ADDENDUM NO. 2

**BREWSTER CENTRAL SCHOOL DISTRICT
BREWSTER HIGH SCHOOL
SECURITY VESTIBULE, SYNTHETIC FIELD AND RELATED WORK**

DATE: May 3, 2024

05-03-2024	BID ADDENDUM #2
DATE	ISSUED TO
SCALE:	AS NOTED
FILE NO.	DRAWING NO.
23505.01	SK-1

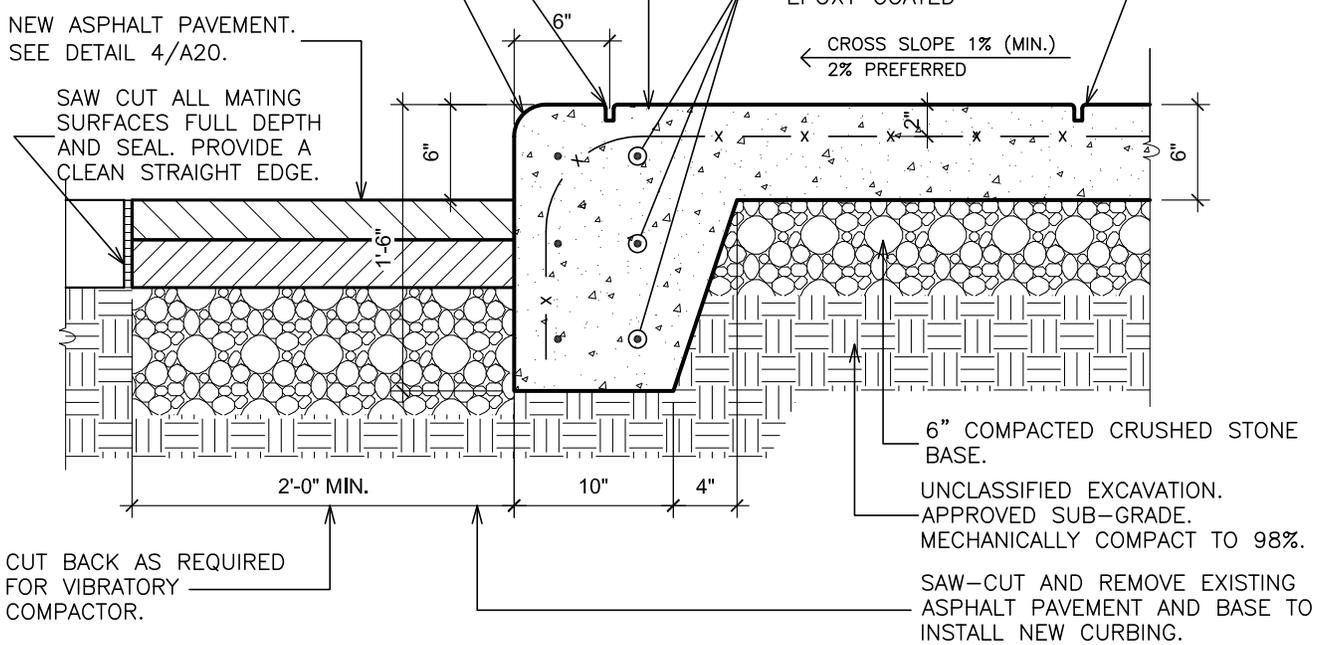
Concrete Curb Detail **ADD** note “Where there is a concrete walk adjacent to a concrete curb, refer to detail as indicated on Sketch Sk-1 attached to this addendum.

SYNTHETIC TURF DETAIL

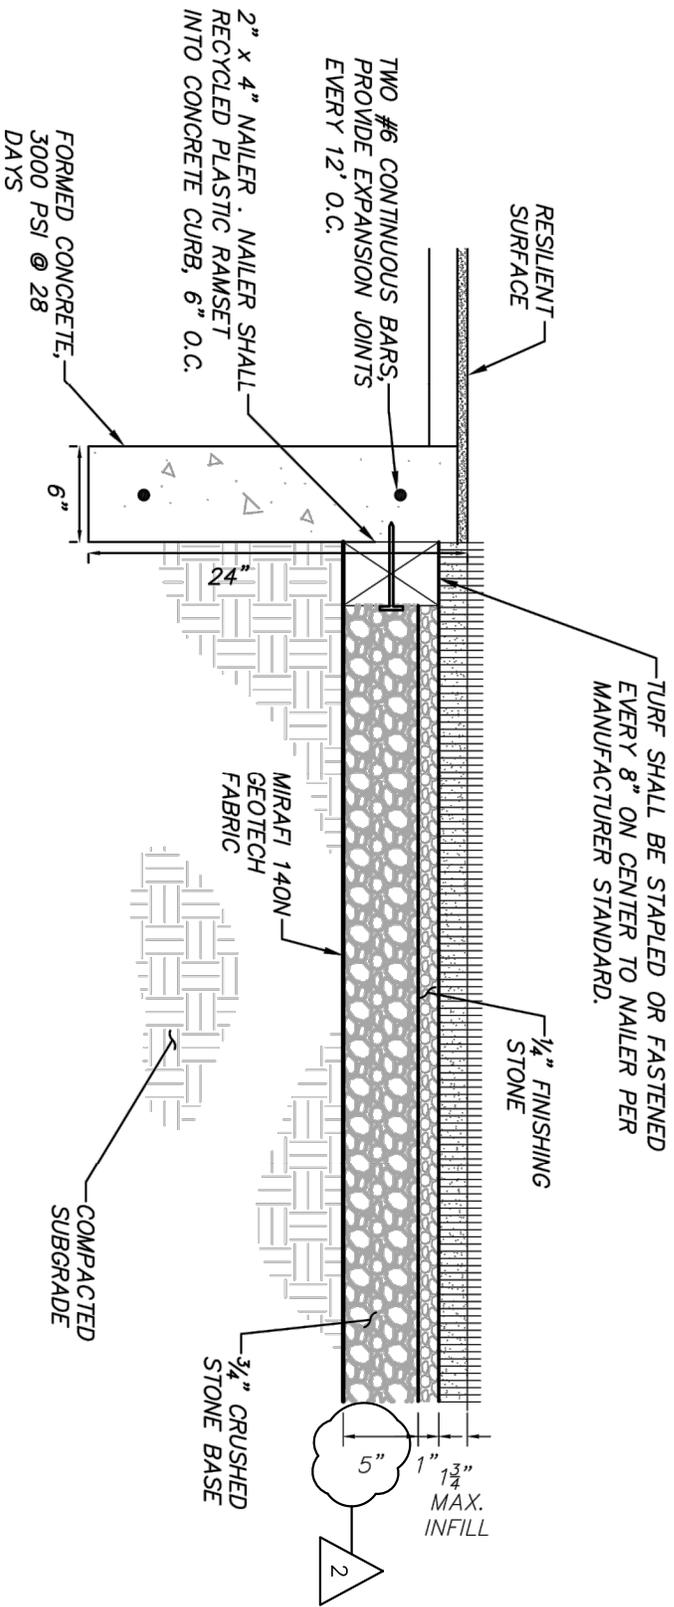
Synthetic Turf Detail, **REVISE** crushed stone base depth as shown on Sketch SK-2 attached to this addendum.

ATHLETIC FIELD DRAINAGE DETAIL
(N.T.S.)

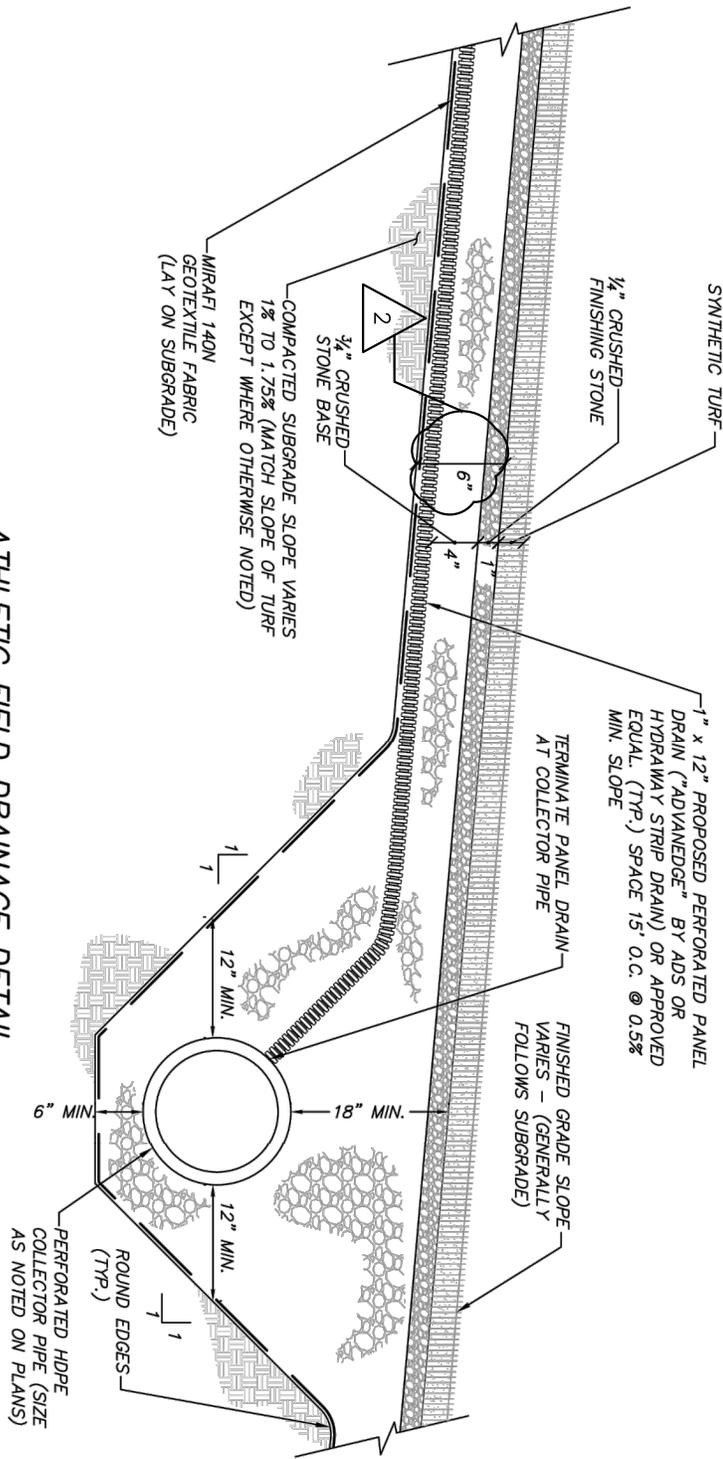
Athletic Field Drainage Detail, **REVISE** crushed stone base depth as shown on Sketch SK-3 attached to this addendum.
